**PLANNING COMMISSION AGENDA
CITY OF PIQUA, OHIO
6:00 PM – TUESDAY, JANUARY 9, 2024
MUNICIPAL GOVERNMENT COMPLEX
COMMISSION CHAMBERS – 201 W. WATER STREET**

Homer Dr Extension Phase II Review Comments (12/22/23)

HOMER DRIVE STREET EXTENSION

PHASE II

STREET SECTIONS

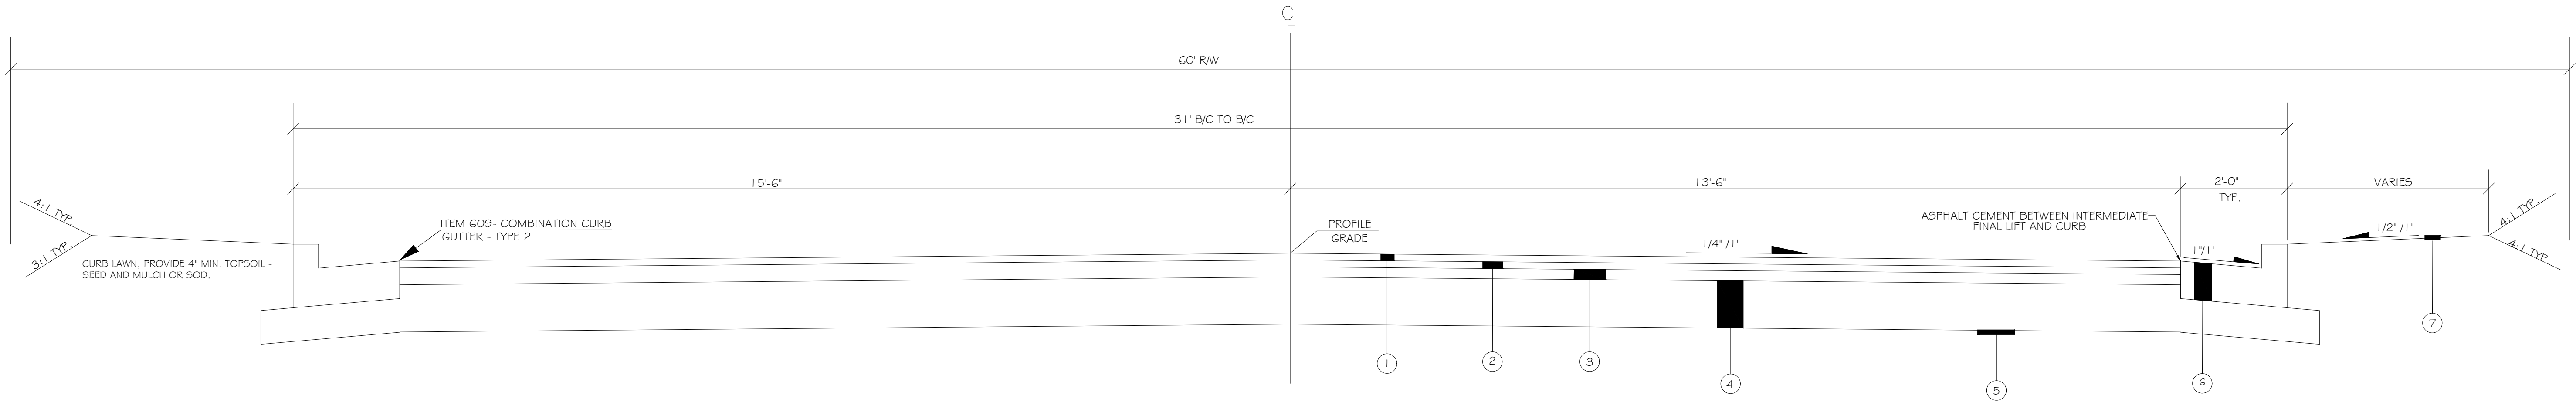
- Asphalt Intermediate Course should be Type 2, it was changed to Type 1
- The cost estimate should not be based on a lump sum bid already received when the plans have not been finalized.

S-6.1 Plan & Profiles

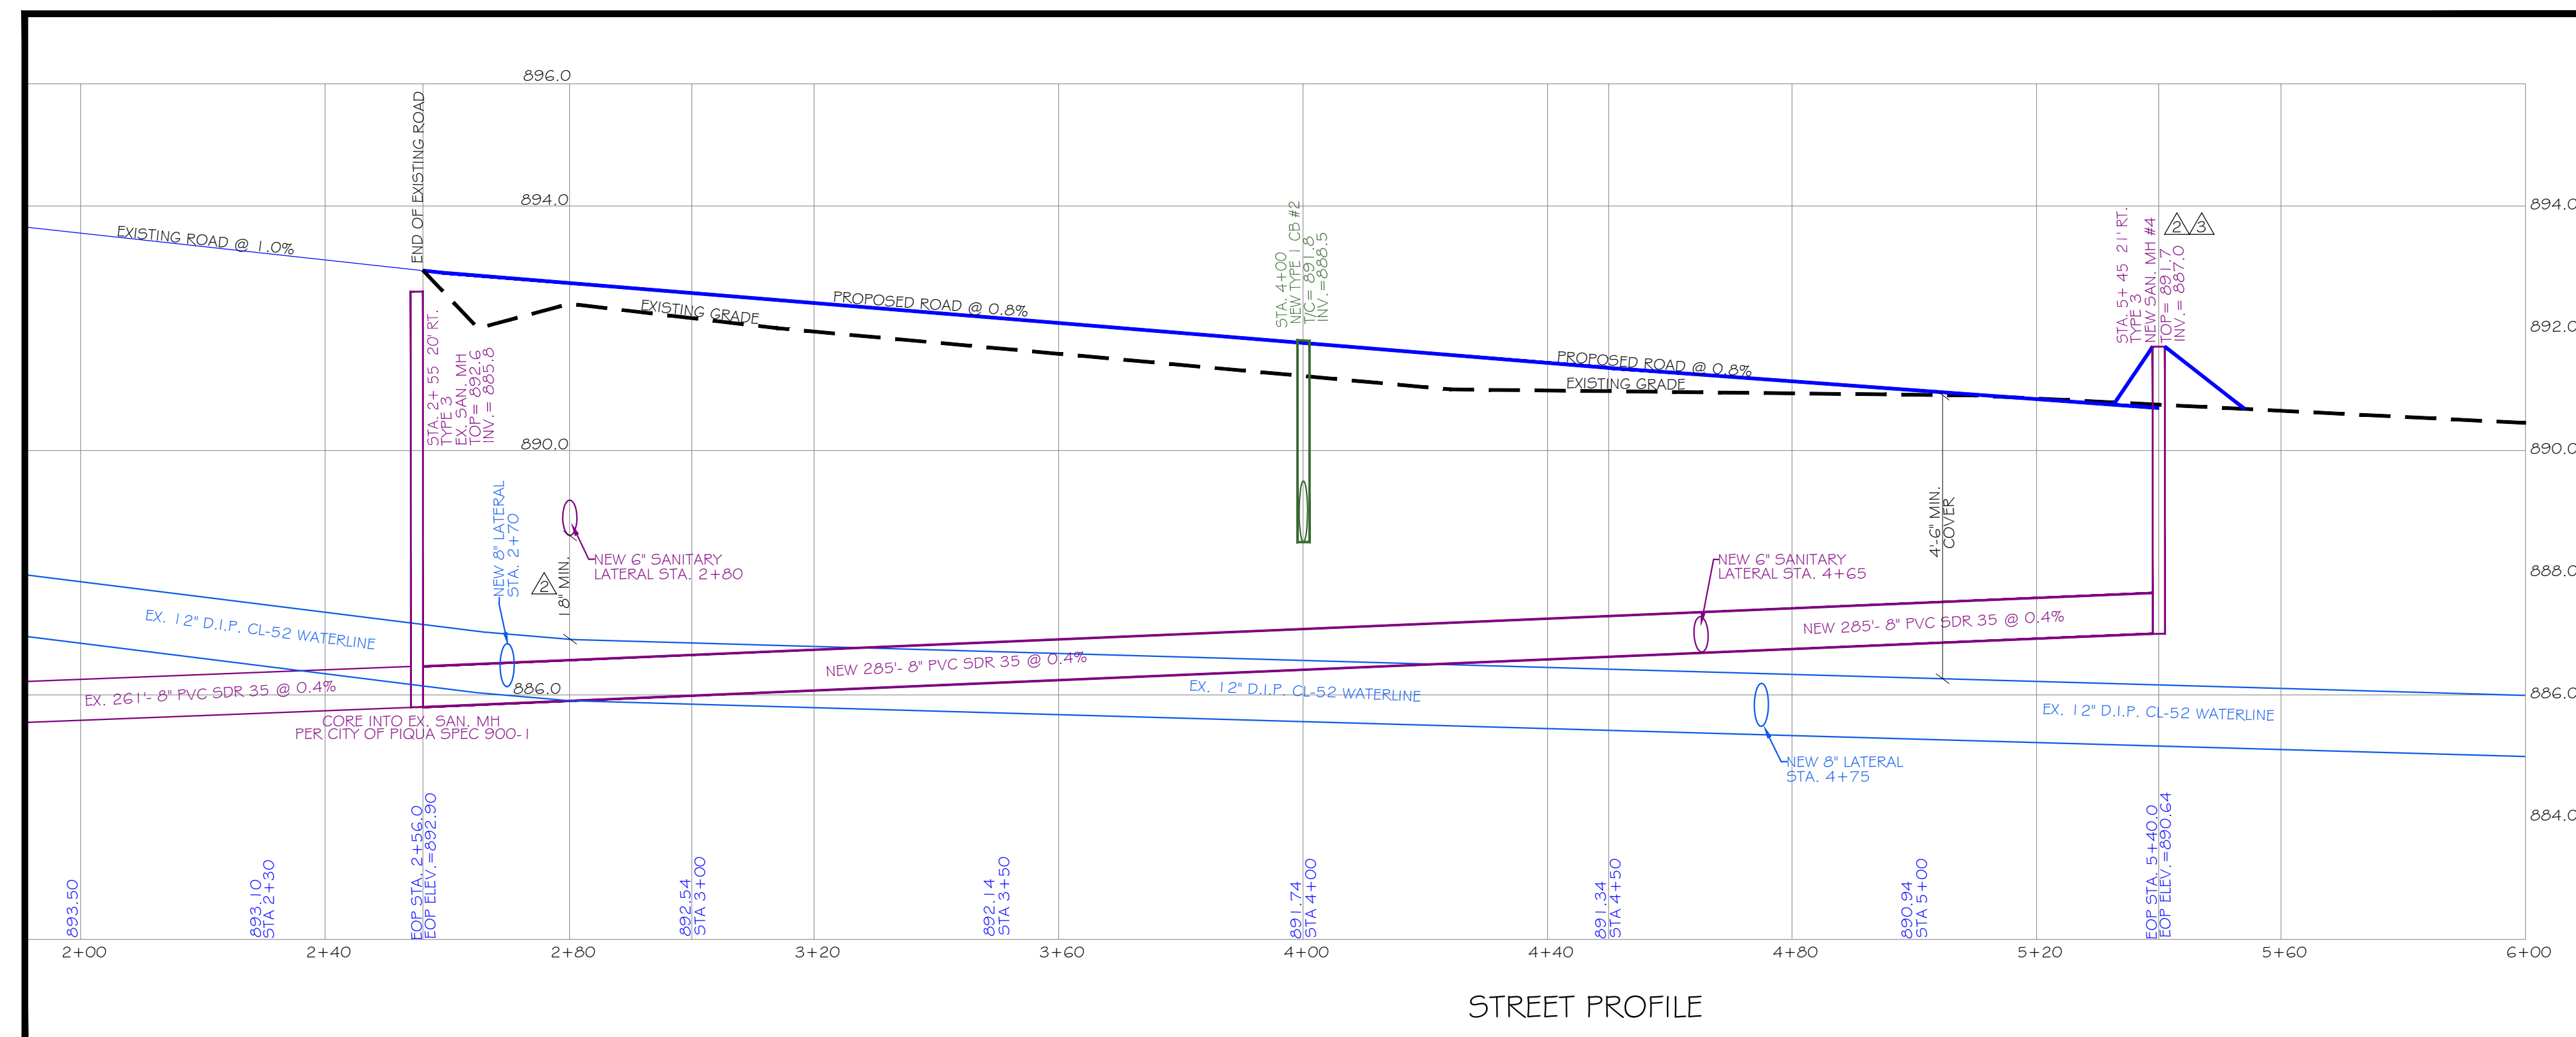
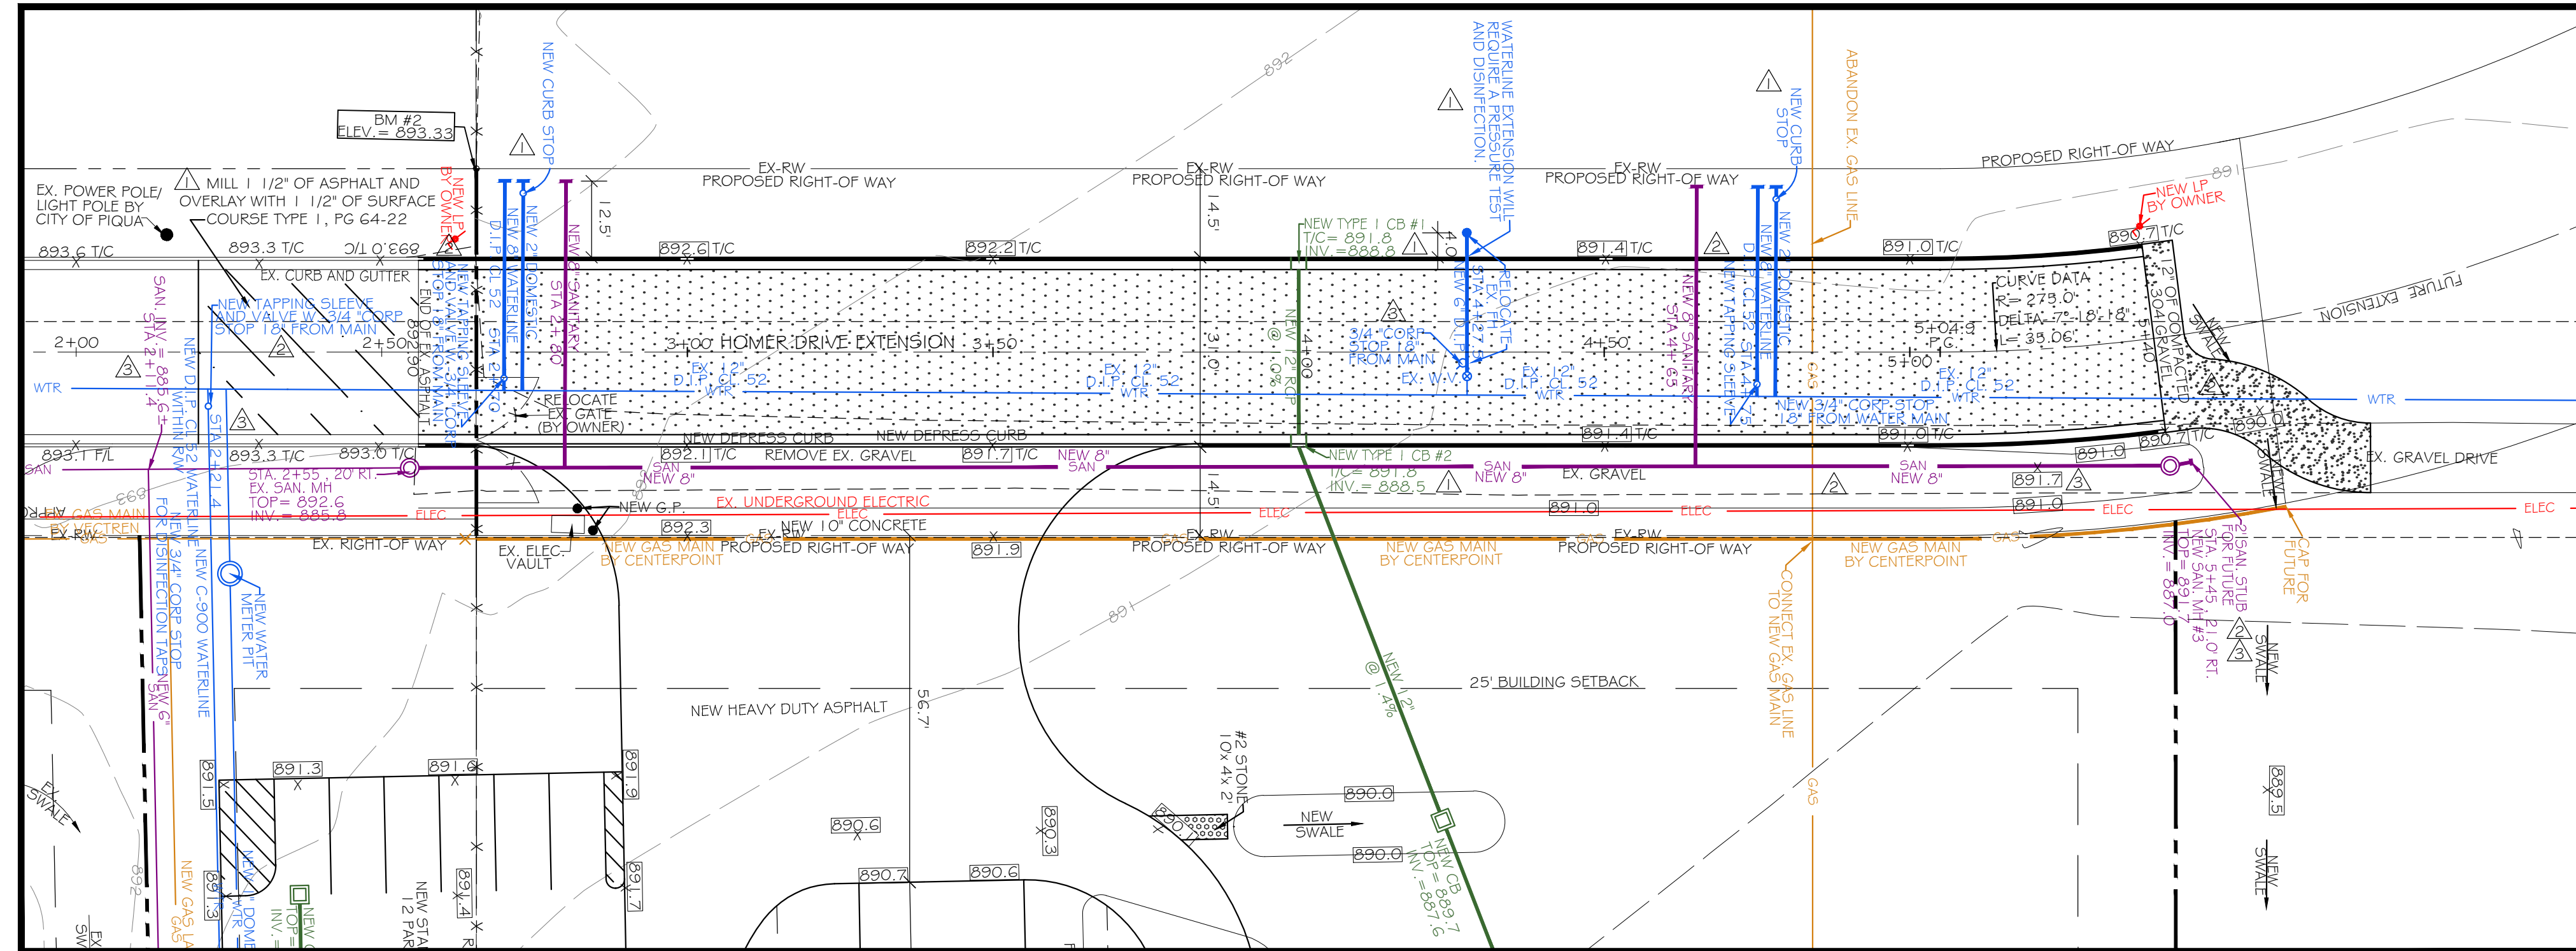
- Sanitary Sewer Main depth should be a minimum of 4'
 - Just south of new sanitary manhole, the cover is not 4'.
 - The "Mound" around the manhole is not permitted. This manhole casting should be close to matching the curb height.
 - This can be fixed by raising the street profile.
